acp-2016-718:

Reply to all comments

Figure 1: MULHACEN overlap function at 532 nm. Extracted from Rogelj et al., 2014. Station height 680 m asl.

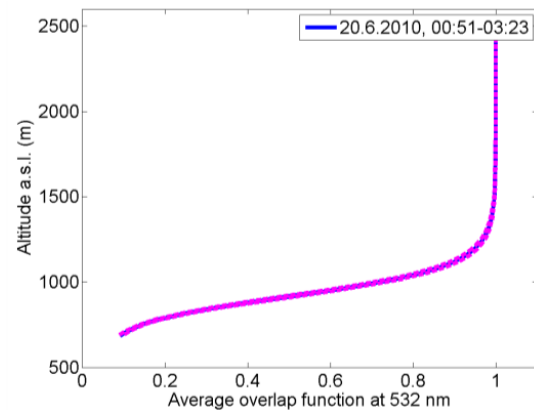
- An lidar instrument discussion is needed: How trustworthy are profiles close to the lidar (overlap issue but also polarization properties).

- 4/8: There are a lot of words on the overlap, but the most relevant number, i.e. the minimum range that can be exploited in terms of MLH, is missing. Why is the 90% overlap-range given as a interval? Is it temperature dependent? If it depends on the channel (i.e., wavelength) but only one wavelength is used in this study, it is not adequate to give a range. It is strange that the polarization channels which are the most relevant in view of the novelty of POLARIS are not mentioned here – whereas the irrelevant Raman- channels and water vapor channels are mentioned.

The following discussion has been included except the figure: *'The optical path of the parallel and perpendicular channels at 532 nm are designed to be identical up to the PBC where the 532 nm signal is split into parallel and perpendicular before reaching the PMT. This setup allows us to assume almost the same overlap for both polarizing components. Thus, the depolarization profile is practically not influenced by the incomplete overlap since it is cancelled out by the ratio of the perpendicular and parallel channels. Only the thermal dilation and contraction of the lidar optics after the PBC might independently change the overlap function of each channel. Since MULHACEN is deployed inside an air-conditioned building, the temperature fluctuation is small and thus, the overlap difference between the channels might be low. Therefore, we assume significant differences only for small values of the overlap function. Navas-Guzman et al. (2011) and Rogelj et al. (2014) retrieve the overlap function of the total signal at 532 nm (sum of parallel and perpendicular channels) by means of the method presented by Wandinger et al. (2000). This study shows that the full-overlap height of MULHACEN is around 0.72 km agl. Assuming that the artefacts due to thermal fluctuations are negligible for overlap-function values above 70%,*

depolarization profiles can be exploited in terms of MLH detection above ~0.25 km agl. Further details about the technical specifications of MULHACEN are provided by Guerrero-Rascado et al. (2008, 2009).'

We agree with the Referee. We have included more information about the overlap of the polarizing channels and discussed the possible influences on the measurements as follows: '*The optical path of the parallel and perpendicular channels at 532 nm are designed to be identical up to the PBC where the 532 nm signal is split into parallel and perpendicular before reaching the PMT. This setup allows us to assume almost the same overlap for both polarizing components. Thus, the depolarization profile is practically not influenced by the incomplete overlap since it is cancelled out by the ratio of the perpendicular and parallel channels. Only the thermal dilation and contraction of the lidar optics after the PBC might independently change the overlap function of each channel. Since MULHACEN is deployed inside an air-conditioned building, the temperature fluctuation is small and thus, the overlap difference between the channels might be low. Therefore, we assume significant differences only for small values of the overlap function. Rogelj et al. (2014) retrieve the overlap function of the total signal at 532 nm (sum of parallel and perpendicular channels) by means of the method presented by Wandinger et al. (2000). This study shows that the full-overlap height of MULHACEN is around 0.72 km agl. Assuming that the artefacts due to thermal fluctuations are negligible for overlap-function values above 70%, depolarization profiles can be exploited in terms of MLH detection above ~0.25 km agl. Further*
